Access Compliance Report

Public Rights-of-Way

Intersection ID: 22417	Main Street: BRACKENBURY_LN	Cross Street: N_BRACKENBURY_LN	Location: SW
ADA ID: 77F371650F0B	Ramp Type: PerpDiag	Initial Pass/Fail: Fail	Overall Compliance: No
		Severity Score: 35

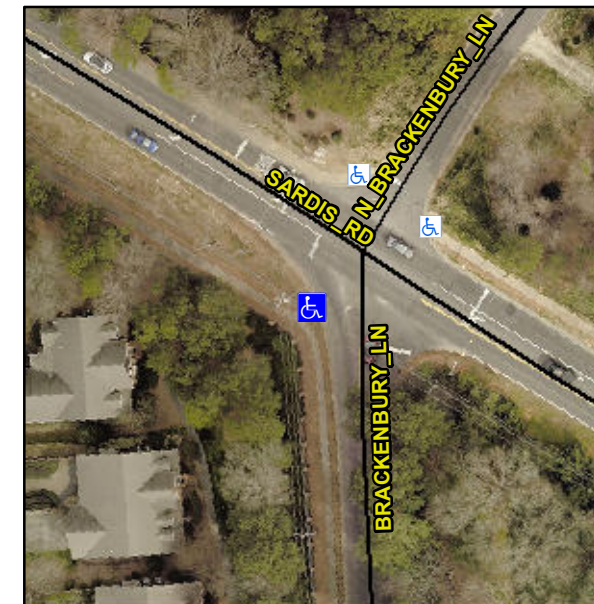
R304.5.1, R304.2.2, R304.5.3

Compliance	Description	Data	Compliance	Description	Data
N/A	Ramp Length (in)	127.0	No	Ramp Slope (%)	12.0
No	Ramp Width (in)	47.0	No	Ramp XSlope (%)	4.2
N/A	Flare Type LT	N/A	N/A	Flare Type RT	N/A
N/A	Flare Slope LT (%)	N/A	N/A	Flare Slope RT (%)	N/A
N/A	Flare Traversable LT?	N/A	N/A	Flare Traversable RT?	N/A
N/A	Landing Length (in)	N/A	N/A	DWS Provided?	N/A
N/A	Landing Width (in)	N/A	N/A	DWS Contrast?	N/A
N/A	Landing Slope (%)	N/A	N/A	DWS Length (in)	N/A
N/A	Landing X Slope (%)	N/A	N/A	DWS Full Width?	N/A
N/A	Landing Curb? (Y/N)	N/A	N/A	DWS Offset (in)	N/A
N/A	Shared Landing?	N/A			
N/A	Gutter Ponding?	N/A	N/A	Gutter Slope (%)	N/A
N/A	Gutter Lip Ht (in)	N/A	N/A	Gutter X Slope (%)	N/A
N/A	Painted X Walk1?	No	N/A	Painted X Walk2?	No
	X Walk 1 Direction	To SE		X Walk 2 Direction	To NW
N/A	X Walk 1 Width (in)	N/A	N/A	X Walk 2 Width (in)	N/A
	X Walk 1 Slope (%)	5.5		X Walk 2 Slope (%)	5.2
	X Walk 1 X Slope (%)	1.9		X Walk 2 X Slope (%)	1.4

Remove & Replace Curb Ramp With Two New Directional Ramps or Equivalent.
